REVISED SUBMISSION TO AEMO

RE: CSIRO 2024-2025 GenCost Report

Consultation Draft – December 2024

Author: Roderick J. Sinclair (BChem, MEngSci, PhD) as a private individual.
5 Eagleview Walk, Doncaster, VIC. 3108
Telephone 03 8803 4231
Email. rjpasincl@gmail.com
24 December 2024

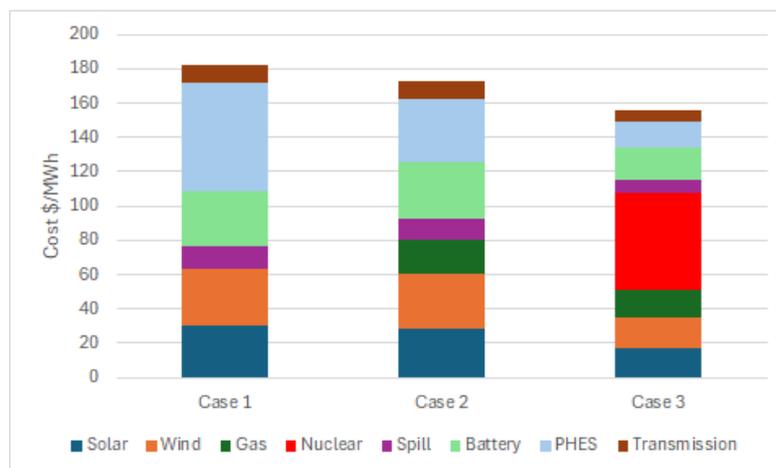
In each case the necessary energy storage is calculated to enable a typical daily and seasonal demand profile to be met at all times. The total annual cost and cost of electricity per MWh is calculated using cost data similar to that given in the GenCost Report with the exception of nuclear for which the capital cost was taken as \$10,800/ kW installed. Results are shown in the following chart.

As illustrated, the cost of electricity generation increases significantly in moving from renewables only to the inclusion of nuclear base load. However, the decline in the cost of storage more than compensates and the overall cost of supply decreases from close to \$180/MWh for renewables to \$155/MWh with base load nuclear in the mix.
